ORIGINATION FORM

Proposed Revisions to a Standard Plans Index (Please provide all information – Incomplete forms will be returned)

SPAN WIRE MOUNTED SIGN DETAILS

INDEX 659-010

====SIGN MOUNTING DETAIL=

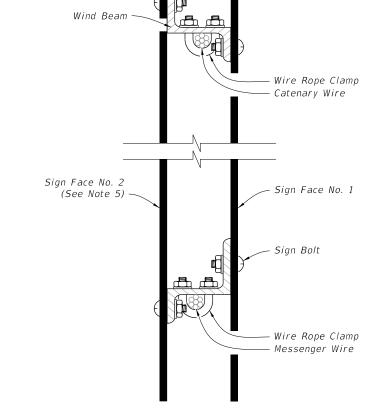
Contact Information:	Standard Plans:
Date: June 28, 2018 Originator: Andre Pavlov Phone: (850) 414-4293 Email:	Index Number: 659-010 Sheet Number (s): 1 of 1 Index Title: Span Wire Mounted sign Details
Summary of the changes:	
Change Notes, Change Sign Mounting Detail; Change Detail of Opposing Signs; Delete Adjustable hanger for Sign Mounting. Delete bottom right corner sub- title.	
Commentary / Background:	
Notes are part of the continuing effort for consistency. (consistency).	Other changes relate to changes for Overhead signs
Other Affected Offices / Documents: (F	Provide name of responsible personnel)
Yes No ✓ Other Standard Plans – Andre Pavlov	
FDOT Design Manual –	
■ Basis of Estimates Manual –	
Standard Specifications –	
Approved Product List –	
Construction –	
Origination Package Includes: (Email or h	and deliver package to Derwood Sheppard)
Yes N/A ✓ Redline Mark-ups	
Proposed Standard Plan Instructions (SPI)
